**Figures and Text Withheld Under 10 CFR 2.390**

**Chapter 1 General Information**

**Figure 3-11**  
**32PTH Basket with SS Rails**

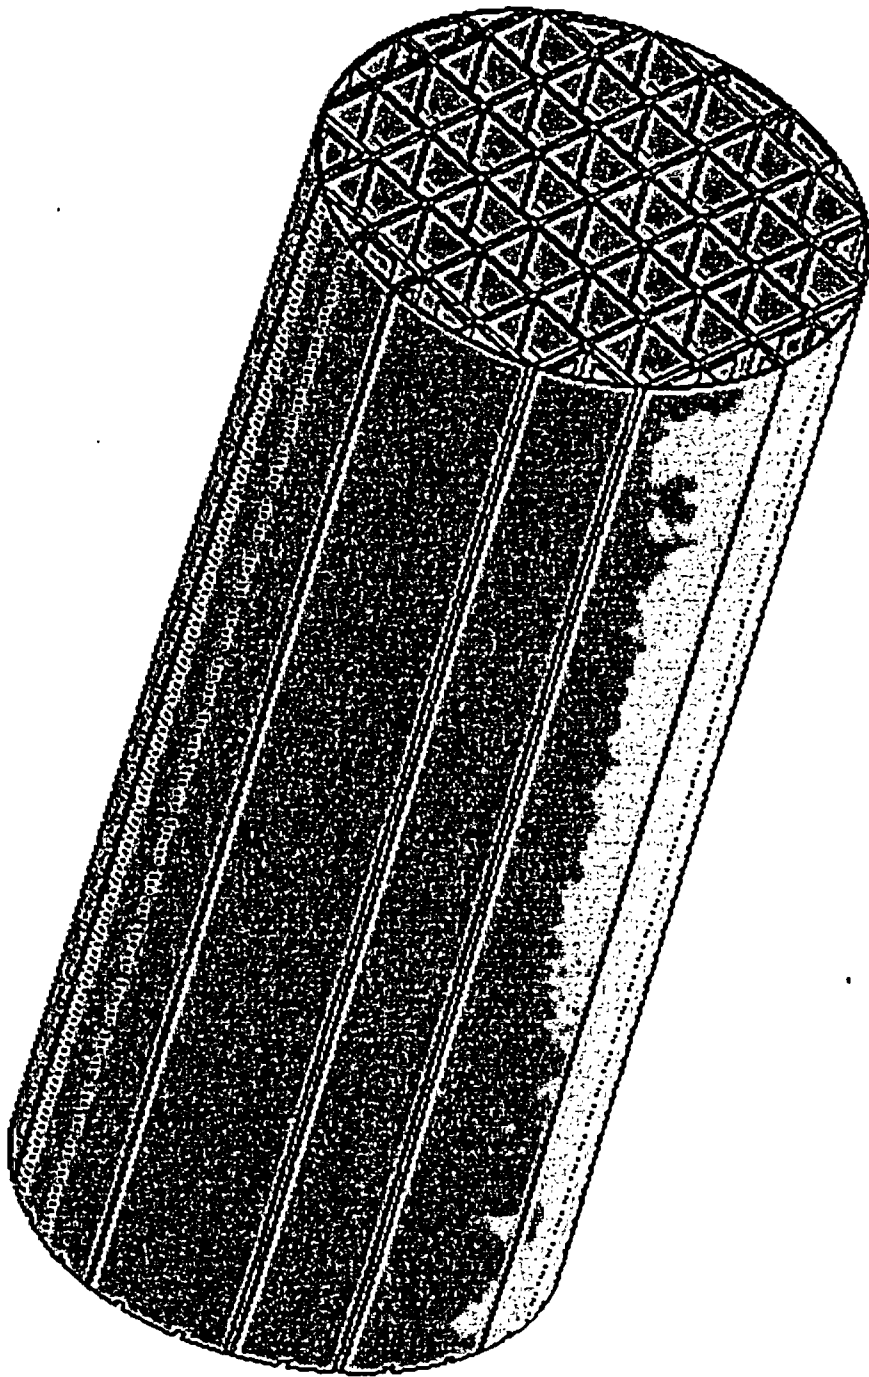
- 3-4 The collapse load approach to evaluate buckling loads of 32PTH DSC fuel basket plates and support rails is not acceptable (See Chapter 3, RAI 1). Given the fact that the fuel basket plate supports are fusion welded to the stainless steel fuel compartments, it is not clear why a small three-dimensional ANSYS finite element model is needed to calculate the buckling load., (Section 3.7.1, 1 2) In addition, the drawing shows the basket plates are aluminum (B209) not SA-240 Type 304 stainless steel. However, the application stated that a buckling analysis of the full size basket was conducted for a 45degree azimuth basket orientation drop (Page 3.9.1-29).. The inelastic finite element analysis converged up to a load of 86,,4g. The design g-load is 75g and thus the safety factor is approximately 86.4g/75g=1.15. Please justify that this small safety factor is adequate to**

**prevent buckling of the basket components during a 75g side drop of the transfer cask. Confirm that the buckling analysis was preformed based on the correct materials and material properties.**

Stainless steel rails are oriented parallel to the axis of the canister and attached to the periphery of the basket to establish and maintain basket orientation and to support the basket. Figure 3-11 of this RAI shows the entire basket assembly with stainless rail.

**Figure 3-19**  
**Transfer Cask Inner Shell & Flange Weld Details**

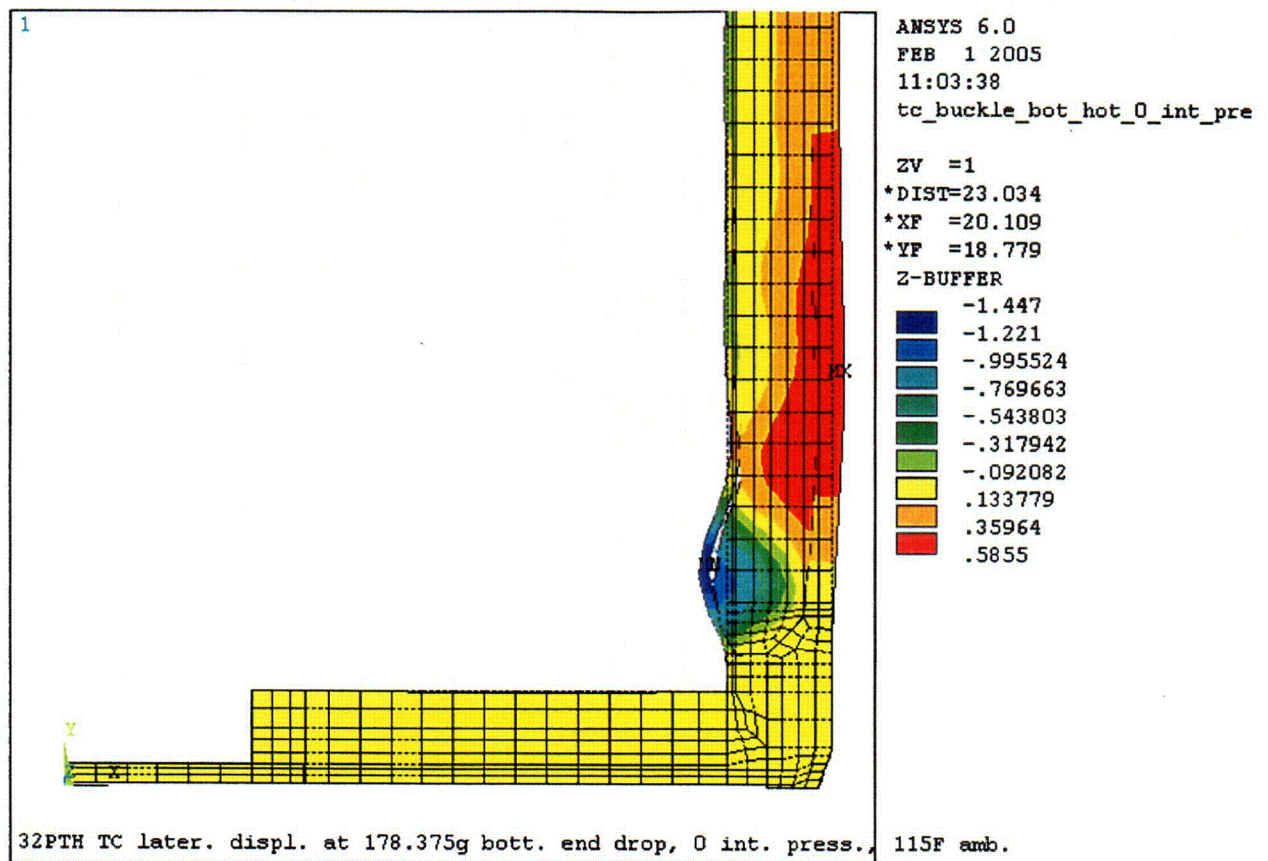
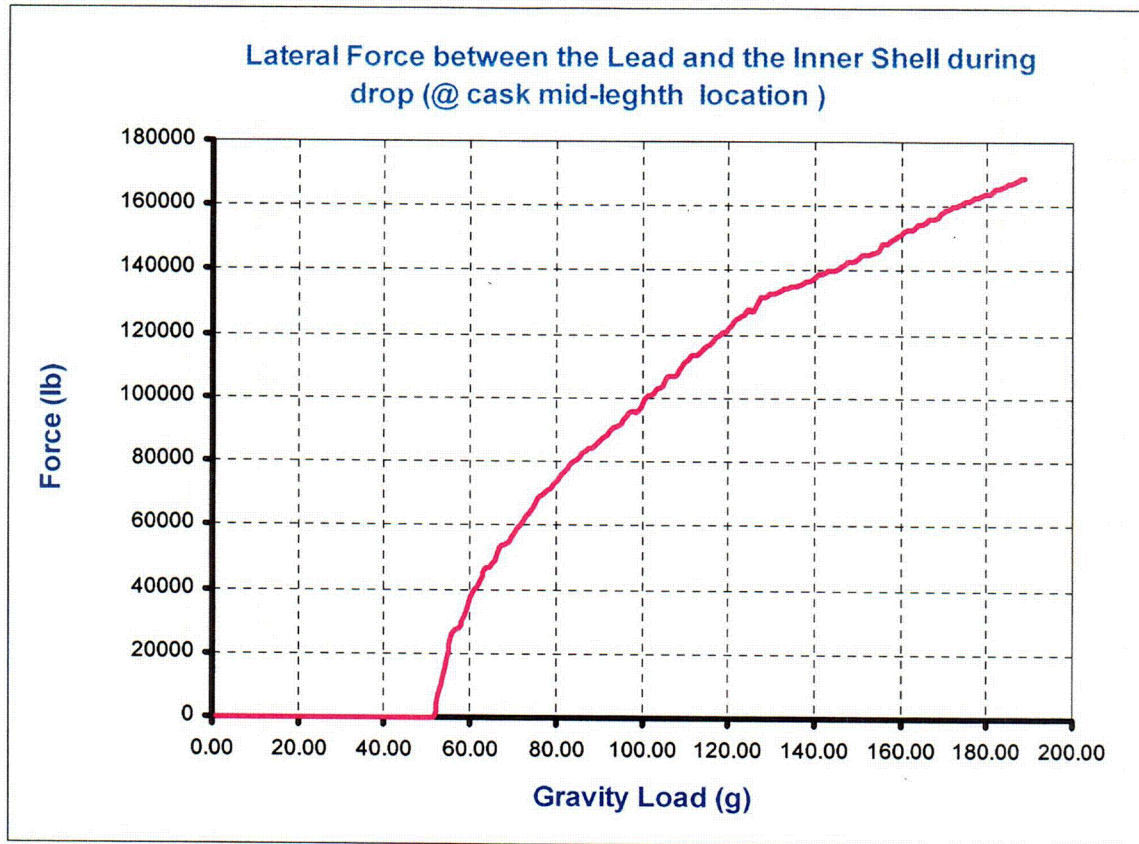
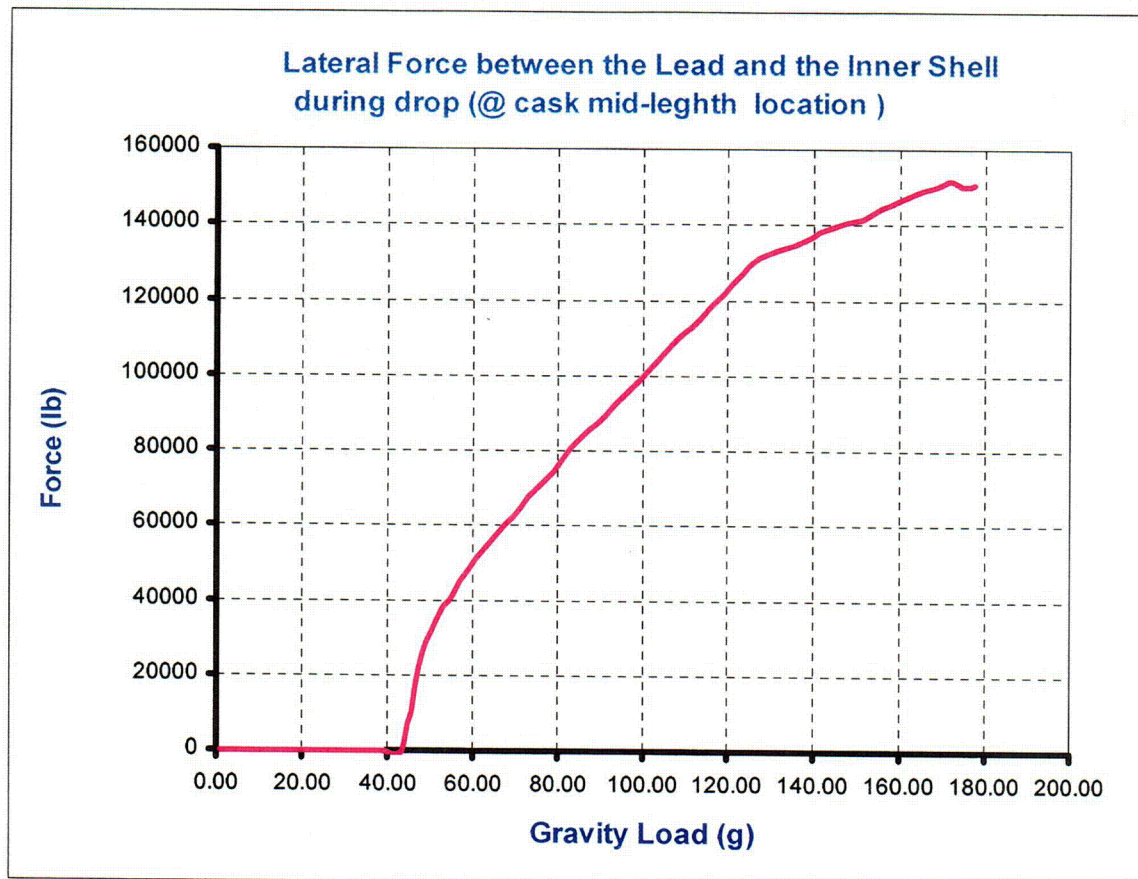
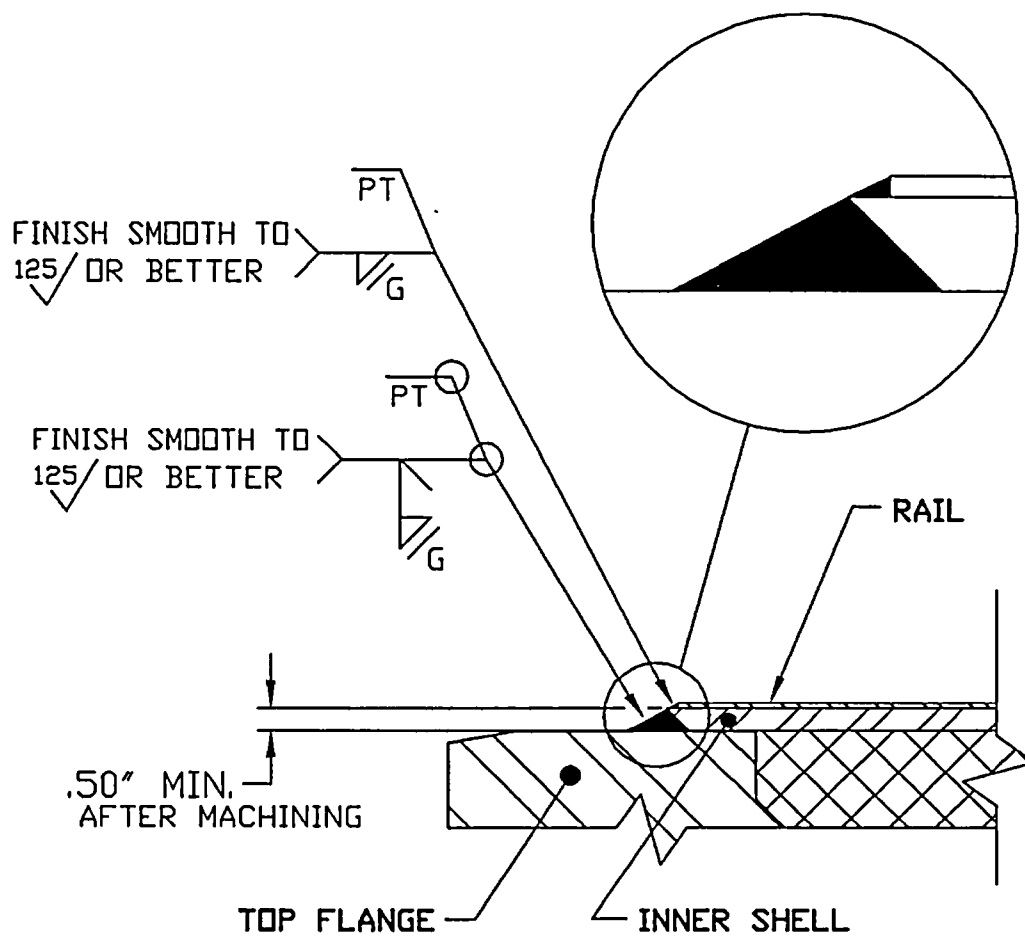
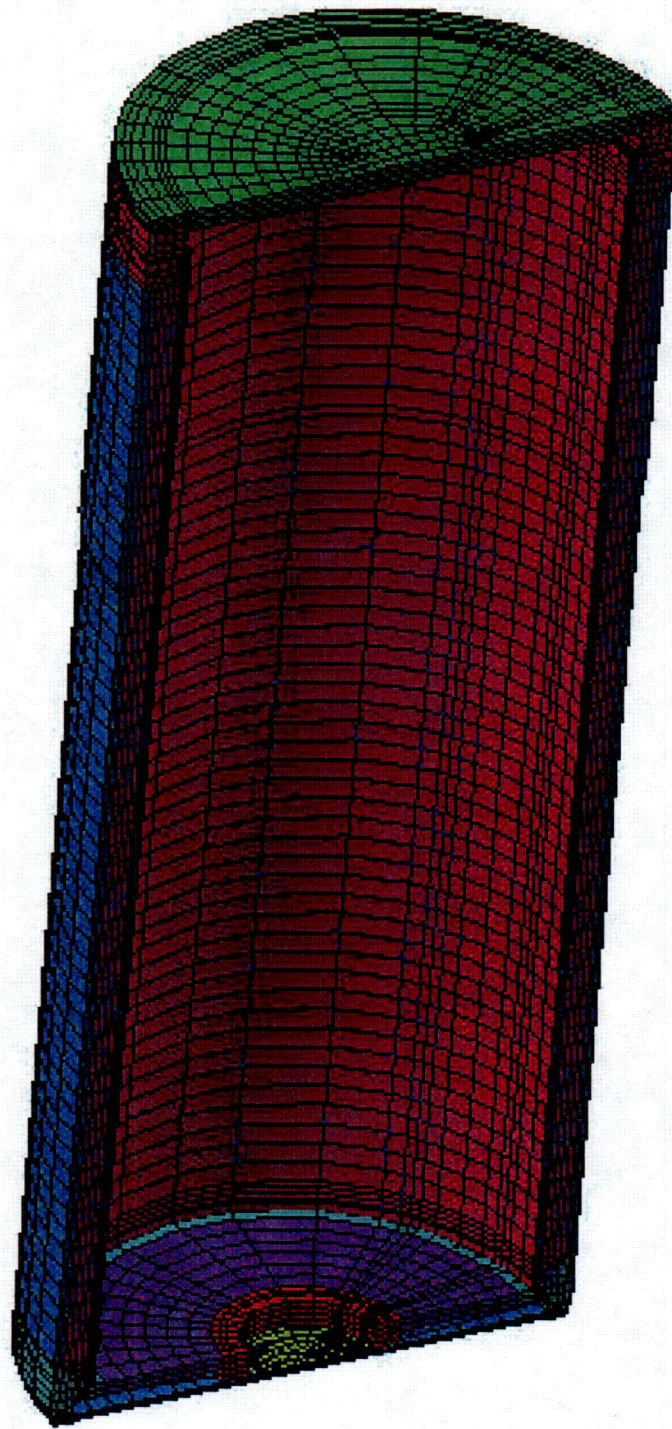
- 3-7 Perform a top end corner drop dynamic impact structural analysis of the transfer' cask to show the adequacies of the top inner shell weld to the top forging.**

**The inner shell is attached to the top flange (forging) by fillet welds ( Drawing No, 10494-72-19)., It is unclear whether the welds have adequate strength to prevent separation of the inner shell from the top flange for a top end corner drop of the transfer cask.**

The inner shell is full penetration welded to the transfer cask bottom plate (see TN drawing 10494-72-19, right side of inner shell assembly view) and also full penetration welded to the transfer cask top flange (left side of the inner shell assembly view). In addition to the full penetration welded to the flange a fillet weld is added to the joint. An enlarge detail of this weld is shown on Figure 3-19 for information. Both weld symbols are called out on the drawing.

**Figure 3-40**  
**Effect of Tempering Temperature on Notch Toughness**

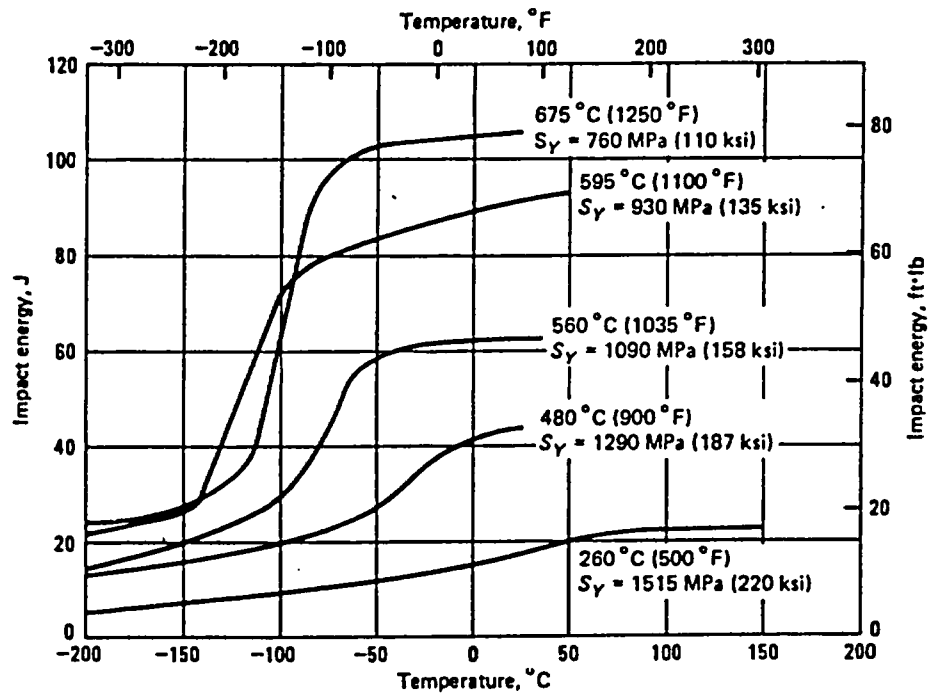
- 3-16 Provide a brittle fracture analysis to evaluate the fracture toughness of the transfer cask bolts,**

ASM Metal Handbook (Volume 1) [3-18], Figure 26 (reproduced here in Figure 3-40) shows that a 4340 steel tempered at 1035°F for 1 ½ hours to produce a yield strength of 158 ksi exhibits a very low Charpy impact transition temperature (< -20°F) and an upper shelf energy of about 45 ft-lbs at -20°F.

**Figure 3-43**  
**Temperature Vs Tensile and Yield Strength for Low Burnup Fuel**

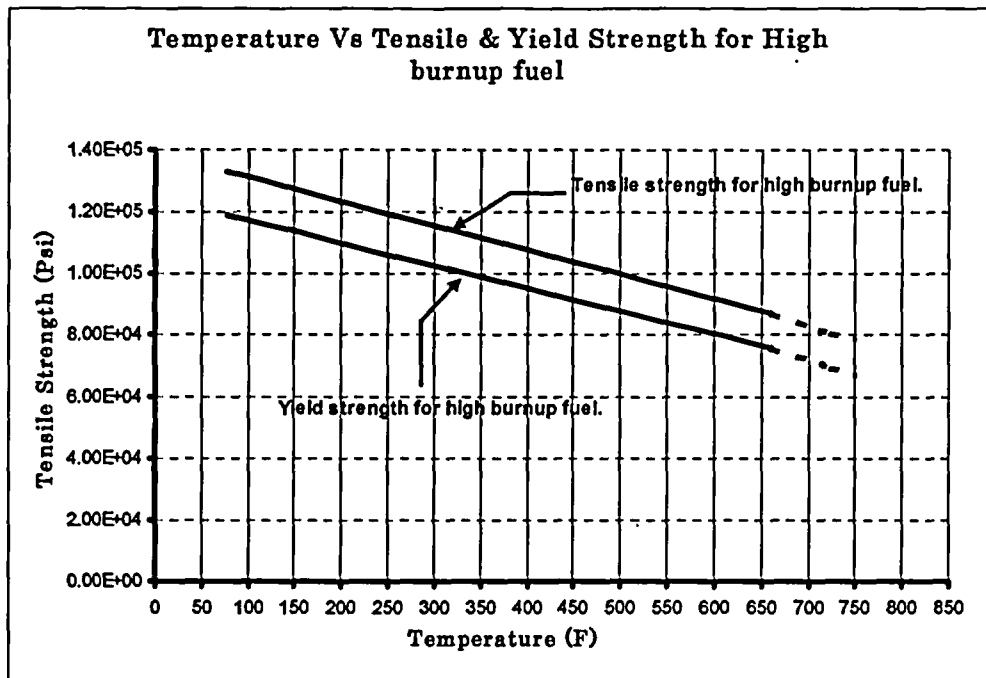
- 3-17 Provide correct irradiated material properties; in particular, the ultimate strength, yield strength, and oxide thickness used for the fuel rod integrity during drop scenario at 750°F. Additionally, show that they are bounding for the irradiated fuel type chosen for the analysis. Further, clarify if an extrapolation was done to obtain the mechanical properties at 750°F, and if so, provide the calculations to obtain the mechanical properties.**

**Yield Strength of cladding:** The yield stress vs. temperature is taken from Table 5 of [3-13, page 12] and is depicted in Figure 3-43. Since the relation between the yield strength vs. temperature is linear, the yield strength at higher temperature is obtained by extending the curve.

**Tensile Strength of cladding:** The tensile strength corresponding to the yield strength at the temperatures is obtained from Figure 5 of [3-13, page 17] and is also depicted in
